HE NgCCM integration issues

Ianos Schmidt, August 26, 2015

NgCCM card size

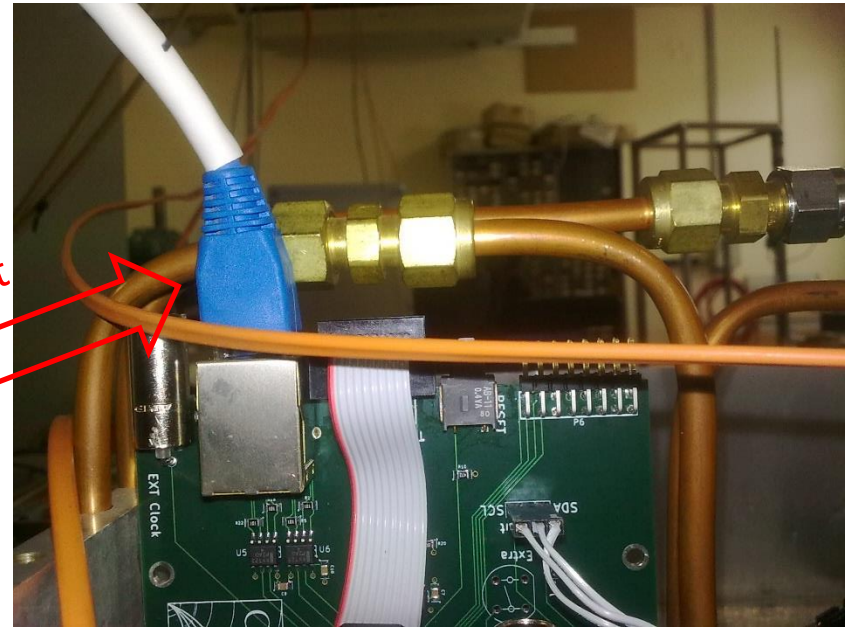
This is not good

160mm cards are too long to fit comfortably under the cooling pipes

Propose reducing length to 140mm.

140mm cards

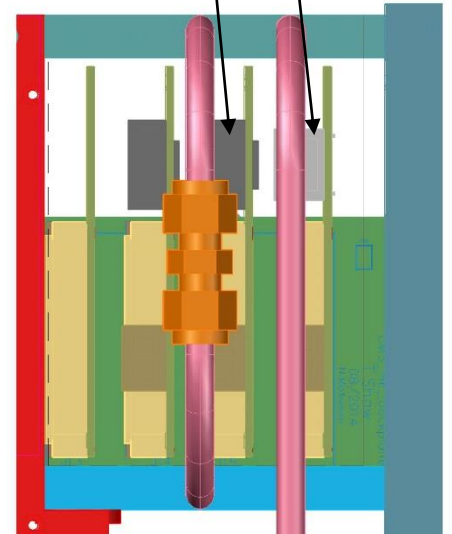
Cooling pipes pass over connectors

NgCCM Width limit

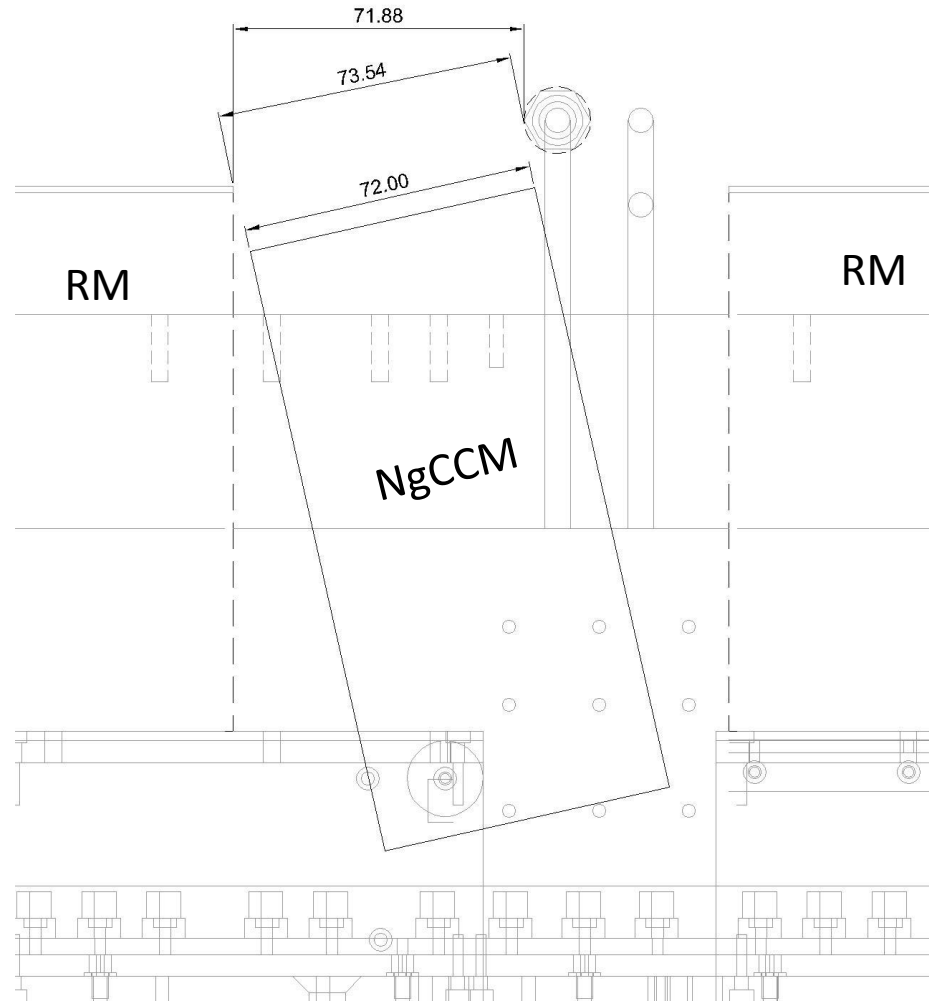
CCM must pass between
RM and cooling pipes
(CU removed)

72mm is the maximum
NgCCM width

Horizontal spacing present situation

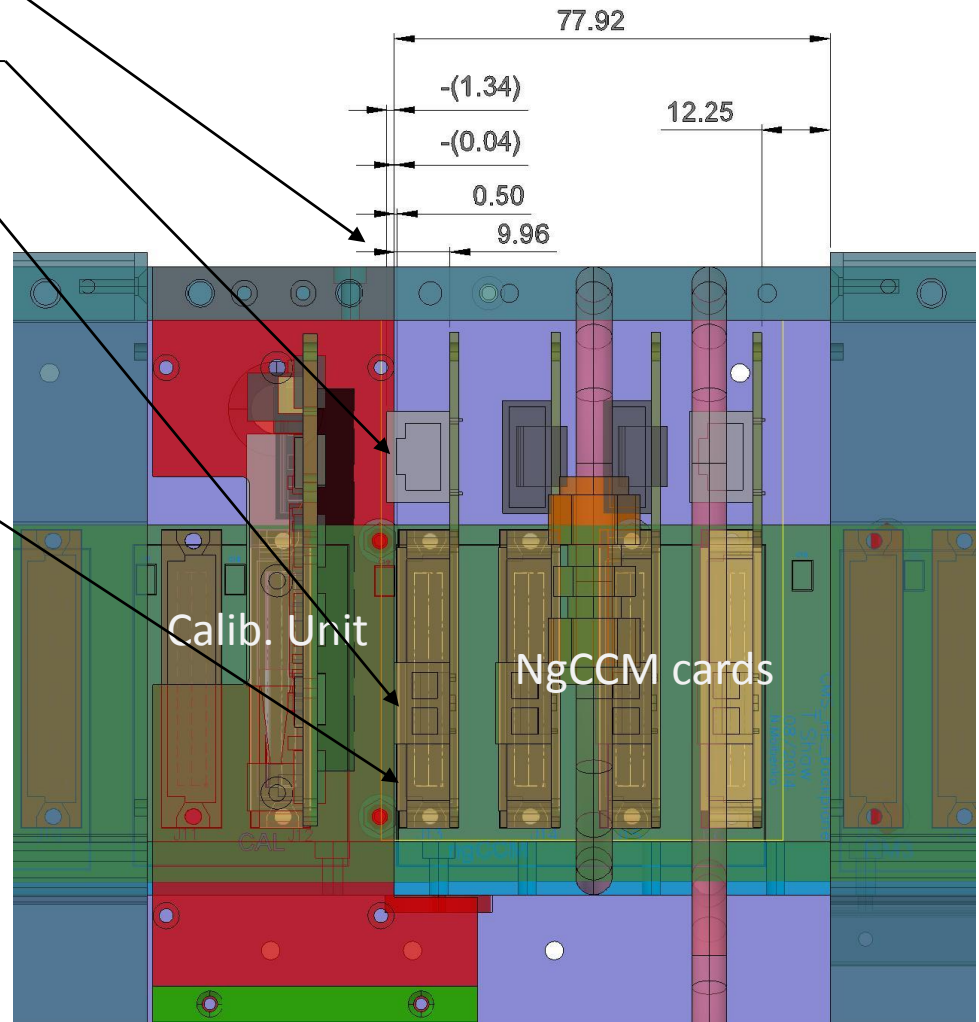
- <10mm between NgCCM card and calibration unit
- RJ-45 connector would interfere by ~1.4mm.
- VTRX would interfere by a hair, but does not include ~2.5mm needed for LC fiber latches
- Any other tall components?
- Above connectors not necessary for card adjacent to calibration module (?).
- NgCCM card backplane connector clears calibration unit by ~0.5mm
- ~12mm between NgCCM card and RM.
- NgCCM can not be wider than 72mm

Possible solutions:

- A. NgCCM card adjacent to calibration module assembled without VTRX and RJ-45
- B. Calib unit made a bit narrower
- C. NgCCM backplane slots shifted away from calibration unit

Option B (reduce width of CU)

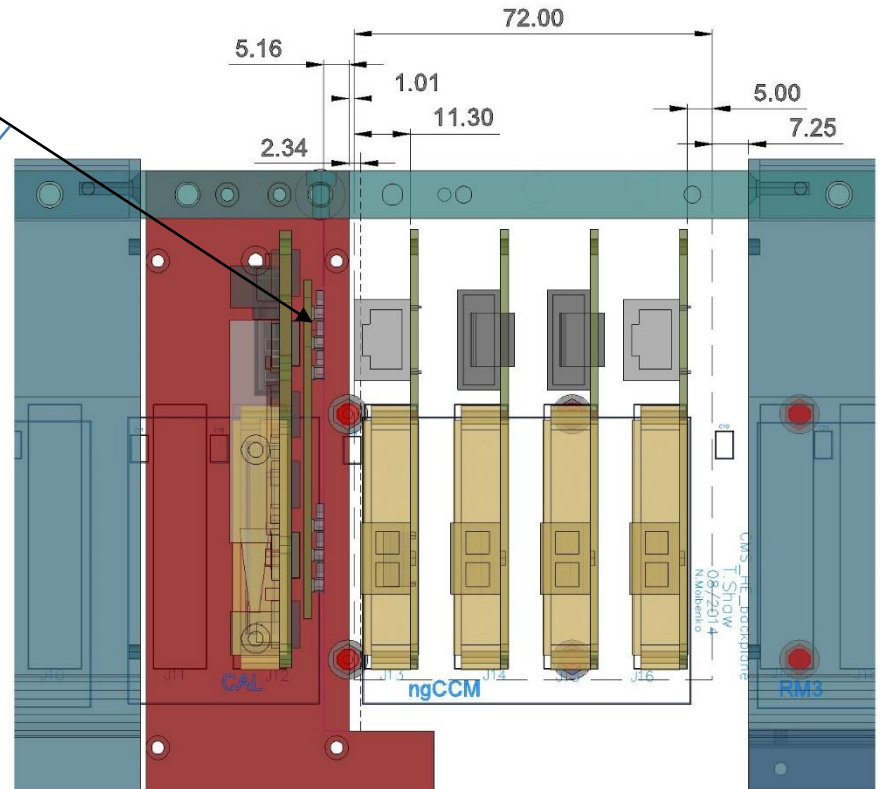
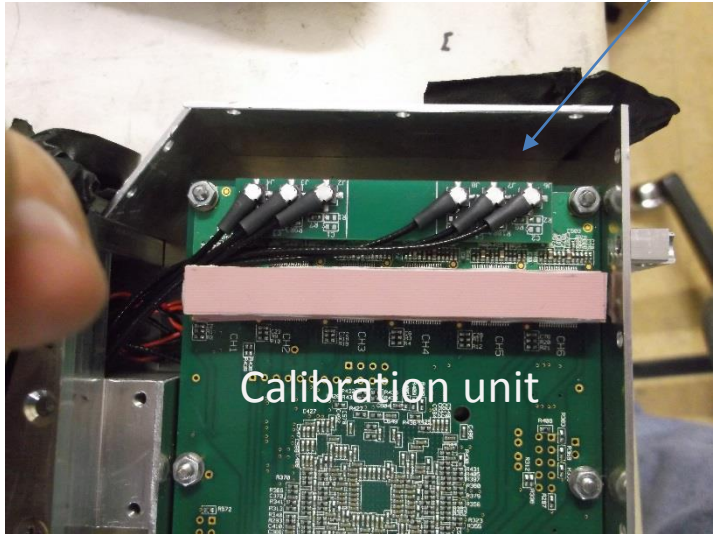
- 2.34mm minimum shift to be able to fit RJ-45
 - Leaves only ~5mm between connectors inside CU and CU edge (maximum effective CU wall thickness)
- Not a good solution unless RJ-45 and VTRX are necessary
